Karori 90% cycleway audit - safety and accessibility

90% design audit

Paneke Pōneke
Bike network plan

July 2023

Figure 5-1: pram crossing with unknown purpose (in red circle)

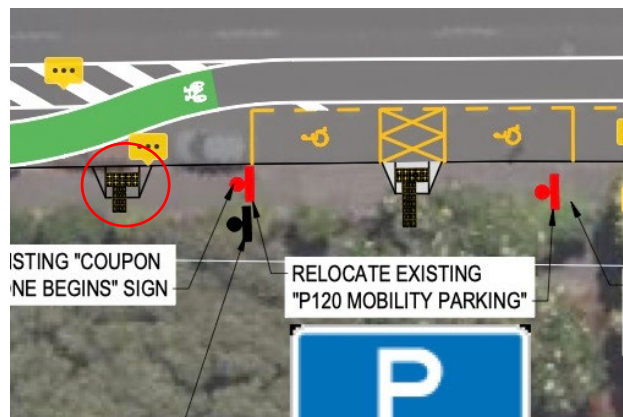
5.1 Kerb ramp to nowhere opposite 30 Glenmore Rd – **P**

Opposite property number 30 Glenmore Road, the signage plan set indicates a new kerb ramp aka pram crossing (shown in red circle in screen snip below) that does not lead anywhere. There is another kerb ramp proposed to serve the mobility parking which appears appropriate. Because this kerb ramp is not shown in the main plan set, it is assumed to be a draughting error. If left in the plans and constructed, it could be a significant safety issue for vision impaired pedestrians.

Probability of crash occurring	Very unlikely
Expected crash severity	Serious injury
Primary treatment recommendations:	
5.1.1	Remove the unnecessary proposed kerb ramp and tactiles.
Supporting treatment recommendations:	
5.1.2	N/A

Designer	Noted, kerb ramp and tactiles will be removed.
Safety Engineer	Agree with CAT and Designer's response.
Client decision	Remove kerb ramp.
Action taken	Kerb ramp removed.

Figure 5-2: Bus stop 4316 is judged to not be a safety issue

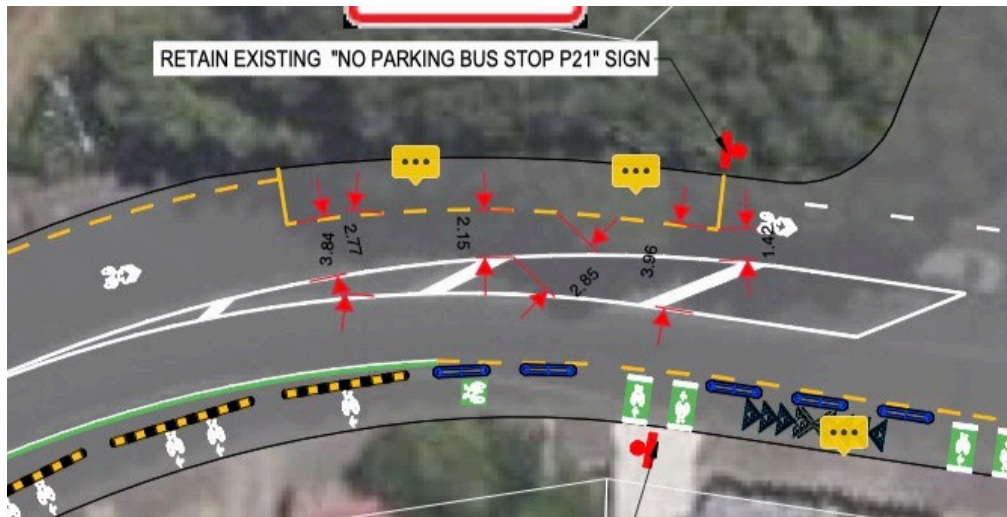
5.2 Lane widths at bus stop 4316 The Rigi – C

The CAT has assessed the lane widths and potential for a pinch point for downhill cyclists at bus stop 4316 The Rigi.

While a 1.42 m pinch point between a stopped bus and the flush median does develop, it is not anticipated that any motor traffic will be stopped in that flush median. This bus stop arrangement is judged to be not a safety issue. This assessment is included in the event a reader questions whether an assessment has been undertaken.

Figure 5-3: kerb ramp and separator layout opposite property 182

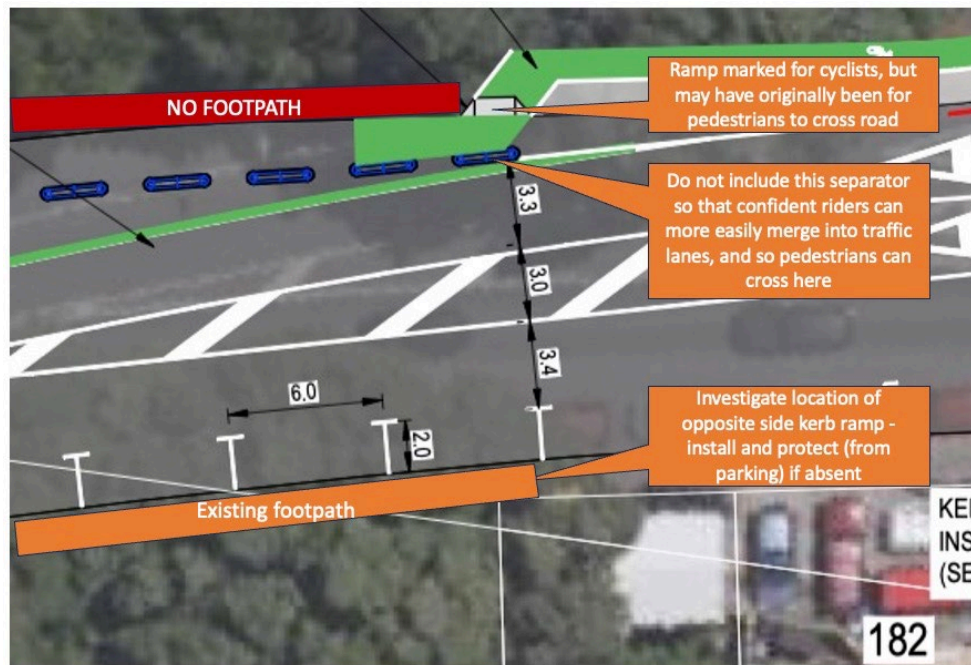
5.3 Kerb ramp blocked near Upland Road – **C P**

An existing kerb ramp marked for cyclist use may have been installed to aid wheeled pedestrians in crossing the road (as there is only a footpath on one side). Safety issues include:

- the kerb ramp on the service station side (if present) may be blocked by parked cars, meaning wheeled pedestrians trying to travel along Glenmore Street may not be able to cross to the outbound bus stop (or vice versa);
- The kerb ramp on the opposite side would now be blocked by the last separator, marooning a wheeled pedestrian in the carriageway; and
- the last separator is too close to the intersection, so a confident rider has less time to exit the separated cycleway and merge with traffic.

- cycle lanes should terminate 30 m before a roundabout as per the CNG and TCD Manual Part 4 section 5.4.5
- there should be a kerb ramp on each side of the road when footpaths end and restart on the other side of the road as per PNG [kerb crossings](#)

Probability of crash occurring		Very unlikely
Expected crash severity		Serious injury
Primary treatment recommendations:		
5.3.1	Maintain crossing pedestrian access to kerb ramp on inside of curve by omitting last separator	
5.3.2	Ensure that there is an accessible kerb ramp not blocked by carparking on the opposite side (the service station side)	
Supporting treatment recommendations:		
5.3.3	N/A

Responses:	
Designer	5.3.1. Last separator to be omitted. 5.3.2. Client has noted that a kerb ramp on the service station side will not be included as part of the Transitional Cycleway project but may be included later as part of the Transformational cycleway Programme.
Safety Engineer	Agree with Designer's response. The Project Manager should ensure that this information on the outstanding missing ramp is retained and accessible for the future transformational team.
Client decision	Agree. Remove separator and inform transformation team on future kerb ramp.
Action taken	Separator removed from designs. Report for Transformational team begun.

Figure 5-5: AMIG-approved transition from cycleway to mixed traffic lane

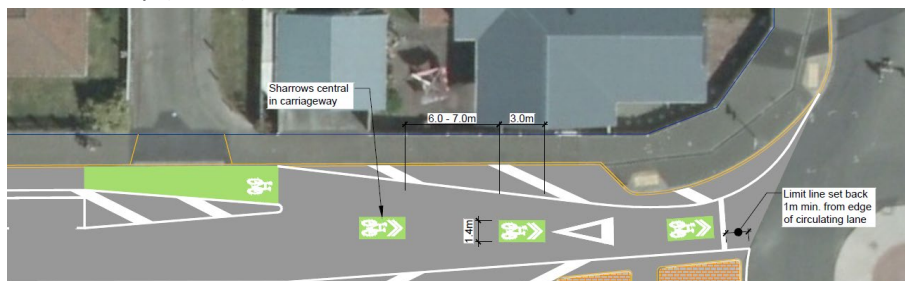
5.4 Unclear transition cycleway to roundabout – C

The separated cycleway has a decision point at its terminus – a shared path ramp for less confident riders and those proceeding to turn left, and a sharrow marking for those more confident riders and those turning right into The Rigi.

The safety issue is that there are no transitional sharrows between the end of the cycleway and the limit line, and motorists may not expect a rider to suddenly merge when there is green paint and an obvious cycle route on the path.

Figure 5-5 shows the current thinking on best practise for a kerbside cycle transition on the approach to a roundabout, with sharrows in green boxes as agreed by the Active Modes Infrastructure Group (AMIG).

Probability of crash occurring	Very unlikely
Expected crash severity	Minor injury
Primary treatment recommendations:	
5.4.1	N/A
Supporting treatment recommendations:	
5.4.2	Provide additional green backed sharrow(s) between the end of the cycleway and the sharrow at the limit line.
5.4.3	Develop a consistent marking plan – some sharrows are green backed and some are not.

Responses:	
Designer	5.4.2. Noted, additional sharrows to be included. 5.4.3. No design response. WCC preference for sharrows with green back to be included only at transitions non-green back throughout as typically used.
Safety Engineer	Agree with CAT and Designer’s response.
Client decision	Agree with designer and safety engineer.
Action taken	Designs change to include additional sharrows.

Figure 5-6: proposed segregated path on inside of curve near Upland Road

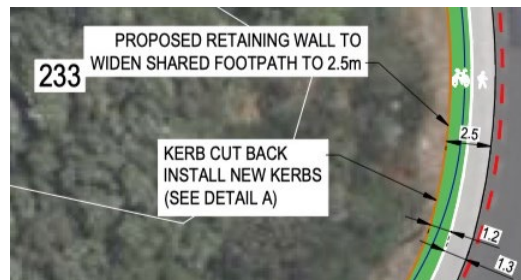
5.5 Segregated path near Upland Road – P C

The designer has proposed a retaining wall to widen the existing footpath to a 2.5 m wide shared path with paint segregation. Some comments:

- The paint separation is not likely to work in practice
- It is understood that the paint separation is intended as a minor aid for people with vision impairment, and therefore it is not seen as a safety issue or harm to include, although the cost/benefit ratio for paint separation is likely to be low
- The widening is worthwhile for the interested but concerned cyclist who would not want to ride on the carriageway
- The number of pedestrians using this segment is expected to be very low so a 2.5 m shared path without paint separation should be adequate
- The plan callouts jumble terminology e.g. “shared footpath”

Probability of crash occurring	N/A
Expected crash severity	N/A
Primary treatment recommendations:	
5.5.1	N/A
Supporting treatment recommendations:	
5.5.2	For clarity, the designer should update the callouts to reference the existing footpath and the proposed shared path

Responses:	
Designer	Design to revert to a shared path instead of a segregated path.
Safety Engineer	Agree with CAT and Designer’s response.
Client decision	Agree with all.
Action taken	Design now shows it as a shared path.

Figure 5-7: proper alignment of return to carriageway minimises turning angle shown with stippled green polygon

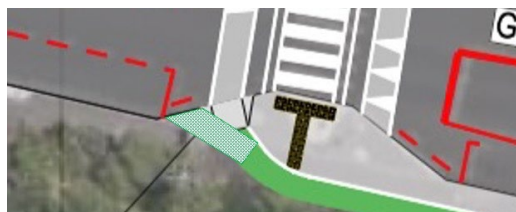
5.6 Cycleway re-entry to carriageway angle too steep – C

The design for the re-entry to carriageway opposite 196 Glenmore Street and 94 Karori Road shows a kerb ramp leading onto the RSP ramp. This kerb ramp should be oriented towards the direction of travel for a cyclist, using the kerb extension as a “shield” from motor traffic in the lane to be re-entered. The safety issue is that if the alignment is constructed as designed, a cyclist will re-enter the carriageway in conflict with a motorist. Cyclists would then be directed into the bus stop space, but this is a relatively uncommon confluence of events and a rider is much more likely to be able to avoid a collision ahead than coming from behind.

The relevant guidance is TCD Manual Part 4, although no specific angle of re-entry ramp is listed in New Zealand documents. Our experience is that the angle should be 70 degrees.

Probability of crash occurring		Very unlikely
Expected crash severity		Serious injury
Primary treatment recommendations:		
5.6.1	Eliminate the conflict point by realigning the kerb ramp as illustrated	
Supporting treatment recommendations:		
5.6.2	N/A

Responses:	
Designer	Noted. Kerb ramp to be realigned.
Safety Engineer	Agree with CAT and Designer’s response.
Client decision	Agree with all.
Action taken	Angle of kerb ramp realigned in the latest design.

Figure 5-10: clip from design plan; green dashed line shows cyclist trajectory

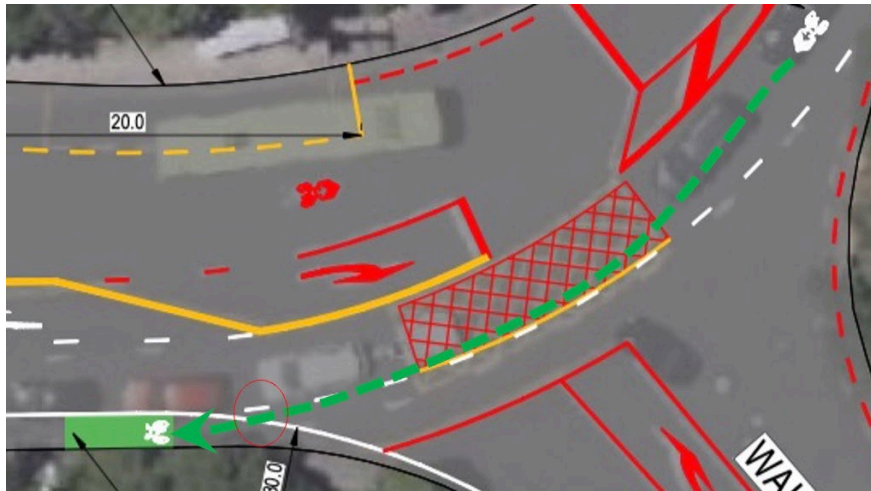
5.7 Incorrect line edgeline marking Glenmore at Waiapu Rd – P C E M
Comment

The edgeline is shown as a continuous white line. Road users are not intended to cross solid white lines. For legibility, the edgeline should be omitted and linemarking designed as per TCD Manual Figure 4-22 (although NZ guidance is not very clear on this point).

Probability of crash occurring	Choose probability
Expected crash severity	Choose severity
Primary treatment recommendations:	
5.7.1	N/A
Supporting treatment recommendations:	
5.7.2	Omit white edgeline at Waiapu Rd

Designer	Noted. Amendment to be made.
Safety Engineer	Agree with CAT and Designer's response.
Client decision	Agree with all.
Action taken	Design updated to eliminate kerb line.

Figure 5-11: the 90% design plan offers no details on the shared path at the Chaytor / Birdwood intersection

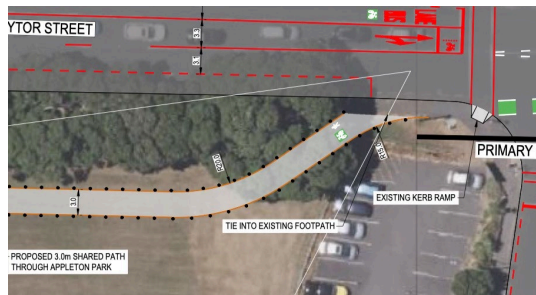
5.8 Entry to Appleton Park shared path – P C
Minor

The safety issue is that there are multiple physical hazards at the proposed shared path entrance point to Appleton Park and none seem to be acknowledged or mitigated in a 90%

design plan. Riders may also not know where they are going or why they are being directed from the carriageway to a pathway, leading to further potential conflicts due to unexpected braking or change of direction.

Probability of crash occurring	Very unlikely
Expected crash severity	Minor injury
Primary treatment recommendations:	
5.8.1	Detail how the shared path will be safely integrated with the existing infrastructure in Appleton Park
Supporting treatment recommendations:	
5.8.2	Include wayfinding signage, possibly in lieu of the rather unnecessary cyclists use ramp sign.

Responses:	
Designer	5.8.1. Noted, will be amended to reflect transition to Appleton park shared path. 5.8.2. Noted, will be amended to include wayfinding signage indicating direction through park.
Safety Engineer	Agree with CAT and Designer’s responses.
Client decision	Agree with the above responses.
Action taken	A widened kerb, green paint and wayfinding added to the designs.

Figure 5-14: clip from Karori Rd part 2 at property number 128

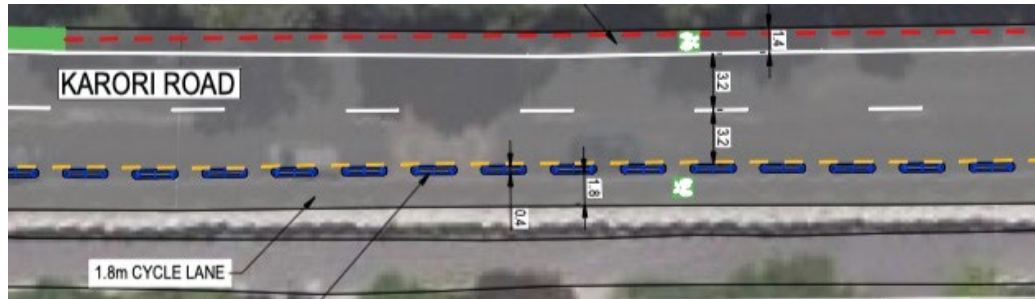
5.10 Lane widths on Karori Road – P C E M

The citybound kerbside cycle lane is proposed to be 1.4 m with two 3.2 m traffic lanes. This is a lane with that is below minimum as per CNG and TCD Manual and will not likely achieve the project objectives (i.e., people will feel unsafe). The 3.2 m traffic lanes are acknowledged to be for the purposes of the design vehicles.

A preferable layout is 3.1 m traffic lanes and 1.6 m cycle lane. Heavy vehicles can encroach when required as there is only paint between the lanes. A narrower traffic lane will also perceptually encourage lower traffic speeds.

5.10.2 | Consider lane width reallocation to encourage more ridership

Designer	Reducing the traffic lane widths results with the 300mm minimum clearance between opposing buses will not be achieved for this section. 3.2m bus lane are required. No change proposed.
Safety Engineer	Agree with Designer's response.
Client decision	Agree with the responses above.
Action taken	No change.

Figure 5-15: lack of ASBs at Parkvale Rd signals

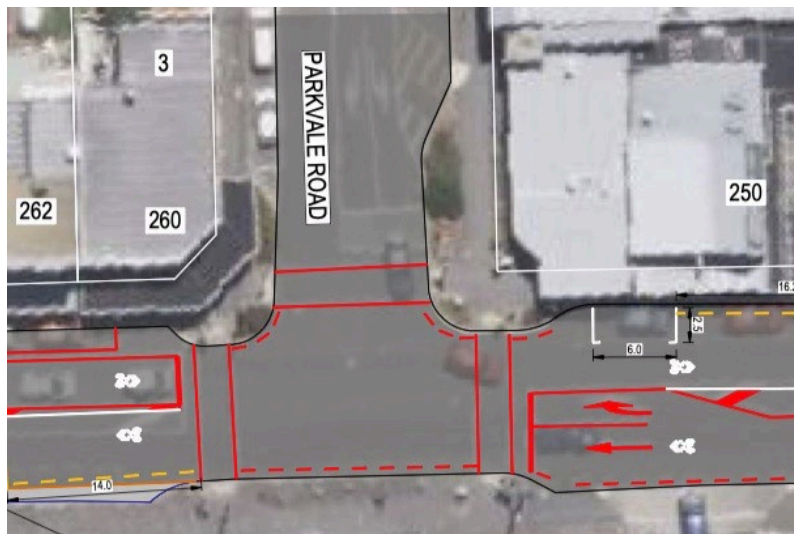
5.11 Missing ASBs at Karori / Parkvale – C

ASBs are not indicated but would help people on bikes in “taking the lane” for right turns.

5.11.2 Consider ASB markings to encourage and legitimise vehicular-style right turns for people on bikes.

Responses:	
Designer	Noted, ASB will be included.
Safety Engineer	Agree with CAT and Designer's response.
Client decision	Agree with CAT and responses.
Action taken	ASBs added to the designs.

Figure 5-16: abrupt transition for people on bikes

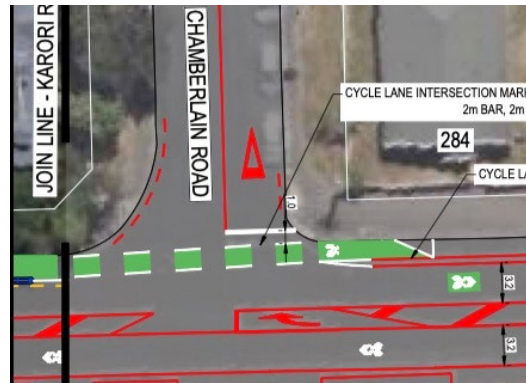
5.12 Abrupt transition at Chamberlain Rd – C
Significant

The safety issue is that the intersection cycle lane abruptly ends on the departure side of the side road, followed immediately by a sharrow in the mixed traffic lane. Motorists will see the obvious cycle lane and may not expect a person on a bike to "pop out" in front of them (even with the proposed sharrow).

5.12.1	N/A
Supporting treatment recommendations:	
5.12.2	Consider a more gentle taper from the cycle lane to mixed traffic and sharrows.

Responses:	
Designer	Recommendation accepted will be amended to extend taper.
Safety Engineer	Agree with CAT and Designer’s response.
Client decision	Agree with CAT and responses.
Action taken	The taper has been made more gentle in the designs.

Figure 5-17: pedestrian refuge lacks accessibility details including kerb ramps

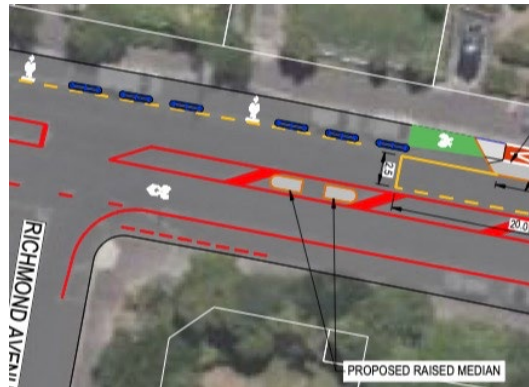
5.13 Pedestrian refuge accessibility near Richmond Av – P

For a 90% design plan, detail is lacking for this proposed median refuge. The safety issues include:

- broken yellow no stopping lines terminate downstream of the crossing point; motorists may park in the way of people trying to use the refuge
- there are no kerb ramps on either side of the road
- the cycleway separators are not spaced to enable pedestrians to cross the road

Probability of crash occurring	N/A
Expected crash severity	N/A
Primary treatment recommendations:	
5.13.1	Complete the design development to show kerb ramps and a clear path of pedestrian travel.

Responses:	
Designer	Noted, will be amended to add ramps on both sides.
Safety Engineer	Agree with CAT, the amended design should include the ramps, BYLs, and revising spacing of cycleway separators.
Client decision	Agree with CAT and responses.
Action taken	Kerb ramps have been added and a separator removed in the designs.

Figure 5-18: xxx

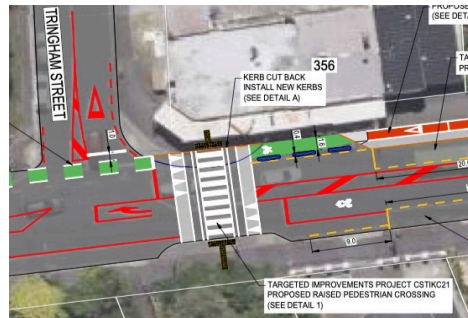
5.14 Tringham St crossing details – P C E M

The plans omit required and desirable pedestrian crossing TCDs. The right turn bay is marked in a lane that appears to be less than the 2.5 m minimum width for a turn bay. A turn arrow is not necessary for motorists to know what the flush median is for. These are assumed to be draughting errors or incomplete plans.

Of more significance is the possibility that right turning motorists will overtake in the central median while a pedestrian is crossing and visually blocked by a stopped vehicle who is giving way properly. The crash type expected is motorist striking a pedestrian. However the right turning motorist will be travelling very slow due to horizontal and vertical geometrics.

5.14.2 Complete the detailing for the Tringham Street pedestrian crossing.

5.14.3 Omit the right turn arrow if the bay is less than 2.5 m wide.

Designer	Required TCDs will be included in the 100% design. The lane markings are existing and are not proposed to be changed. No design change proposed. The pedestrian crossing currently exists with this lane configuration.
Safety Engineer	Agree with Designer's response.
Client decision	Agree with designer and safety engineer.
Action taken	TCDs to be added. Otherwise no change.

Figure 5-19: flush median adjacent to an inline bus stop

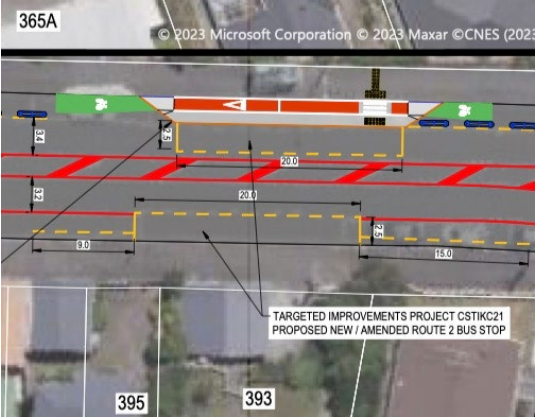
5.15 Flush median adjacent to in-lane bus stop – P C E M

The safety issue is that a motorist may be tempted to overtake a stopped bus using the flush median while:

- Another motorist does the same thing in the opposite direction
- One of the stopped buses pulls out, with the bus driver not expecting an overtake

5.15.1	Install a raised median which can double as a pedestrian crossing facility
--------	--

Responses:	
Designer	The inline bus stop removed after consultation and reduces the risk identified.
Safety Engineer	Agree with Designer’s response.
Client decision	Agree with designer and safety engineer.
Action taken	Bus platform removed from design.

Figure 5-20: Karori / South Karori roundabout proposed markings

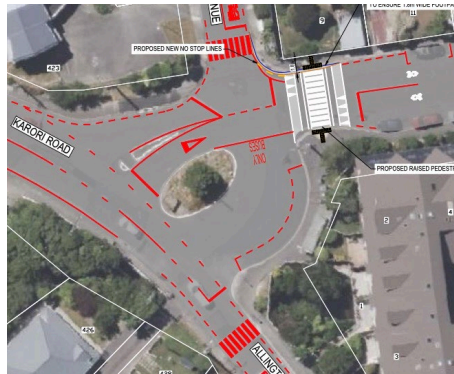
5.16 South Karori roundabout markings – C

The safety issue is that motorists entering the roundabout look for other motorists and fail to see people on bikes. This is an unusual roundabout including a bus only element – motorists are already going to have a high workload. Adding more green backed sharrow markings may help remind motorists of the presence of people on bikes.
 The crash type/s expected right angle crashes due to the “looked but failed to see” issue.
 The risk factors are traffic volumes and speeds.
 The relevant standards are in the CNG.

5.16.2 Consider green backed sharrows on all approaches and in circulating lanes

Responses:	
Designer	Recommendation accepted as WCC indicated preference for sharrows with green back to be included in roundabout.
Safety Engineer	Agree with CAT and Designer’s response.
Client decision	Agree with all above.
Action taken	Green back sharrows added to design.
